Assessment of Twenty-Eight (28) Trees  
At Sunrise Senior Living Facility, Redwood City (Proposed)  
(Multiple Residential and Commercial Lots)  
2915 El Camino Real  
Redwood City, California

Walter Levison, Consulting Arborist (WLCA)

5/5/2017

## 10.0 Tree Location Map Mark-Up (WLCA)

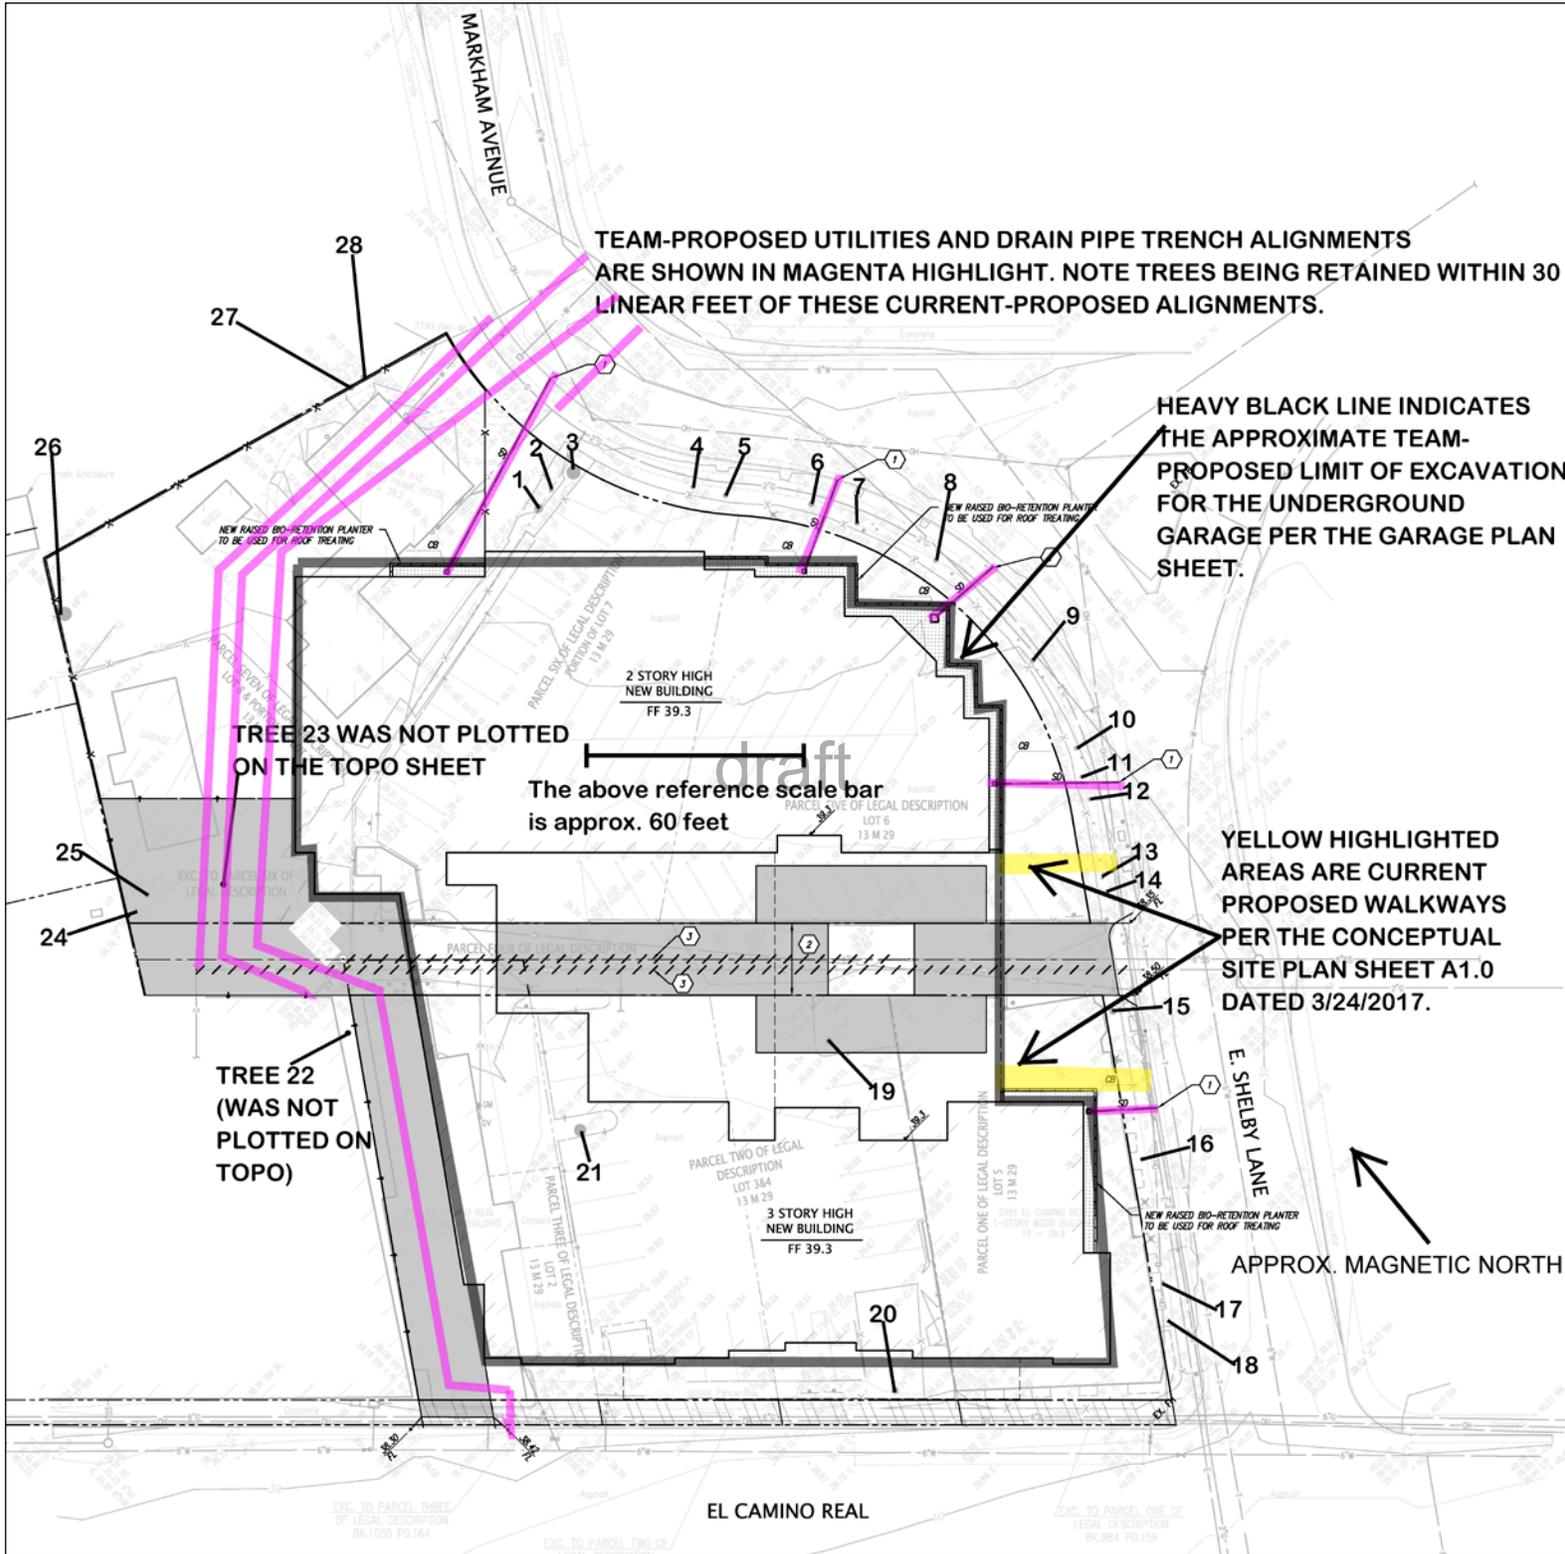
Trees most likely to be affected by trenching are **trees #1, 2, 3, 6, 7, 11, and #12.**

Consider realignment of the proposed walkway that is currently proposed to extend directly adjacent to tree #13 being retained. WLCA suggests adjusting the walkway such that the walk edge is at least **10 feet offset from the tree #13 trunk.**

**Oaks #1, 6, 7, and #10** are lopsided to the south and/or west, and will be in direct conflict with the proposed new Sunrise building footprint exterior, or at least the scaffolding that will be erected around the perimeter of the new building. Other tree specimens may also be in conflict with the proposed building footprint (not verified at the time of writing).

**Oaks #1 through #7** likely exhibit horizontally extended root systems that extend 30 to 40 feet radius (or more) southward and westward, coursing through the old base rock just underneath the existing asphalt parking lot.

The following map is a markup by WLCA utilizing the current proposed grading and drainage plan sheet. The tree plot dots were surveyed by the project surveyor. Numbers indicated on the markup are tree tag numbers affixed to each tree by WLCA. The black lines shown next to each tree tag number end at each trunk plot dot.

WLCA assumes that these proposed utility, drainage, and walkway items can be adjusted as necessary to avoid destroying the root systems of important trees being retained, such as native oaks in good overall condition (see the Excel tree data charts for more details in individual trees).

It is suggested that the project team verify that all proposed trench routes for all utilities and drainage pipe alignments (including landscape plant and tree irrigation pipes). **The finalized alignments need to maintain a minimum of 20 to 30 lateral feet offset between trench edges and tree trunk edges of all trees being retained**, except in special cases such as for trees #27 and #28 where the trenches will be aligned through a historical residence foundation at 10 to 20 feet from trunks (i.e. an area which is assumed to have been an impediment for most tree root growth and would therefore theoretically not contain a dense tree root mass).

**A suggested minimum distance is 25 to 30 feet from excavation cut to tree trunks.**

**Use of vertical shoring is the preferred alternative** to use of an OSHA layback cut. Shoring can be used to hold up the soil in a safe manner for construction personnel while the garage area is built below grade.
